Access Compliance Report Public Rights-of-Way (Pedestrian Signals)

Main Street: VALENCIA_AVE Cross Street: VALENCIA_AVE Location: SE

ADA ID: SGAT220218173410 Signal Type: One Push Button-Non APS Overall Compliance: No Severity Scores: BTN 1: 35 BTN 2: N/A No BTN: N/A

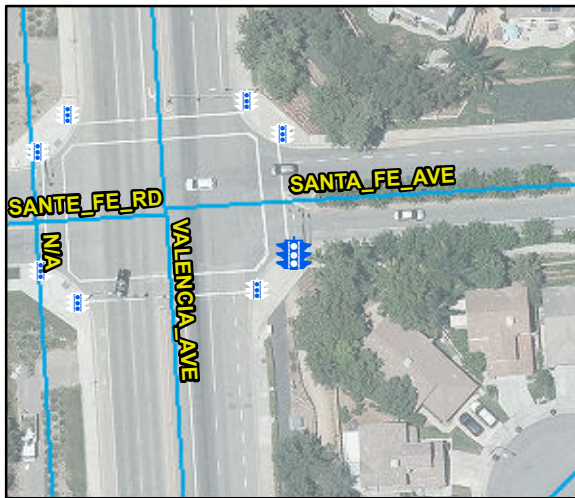
Possible Solutions: Replace Signal Push Button With APS Button. Remove and Replace Clear Space.

OC Std/PROW: R404.2, R404.3, R403.4, MUTCD 4e.08
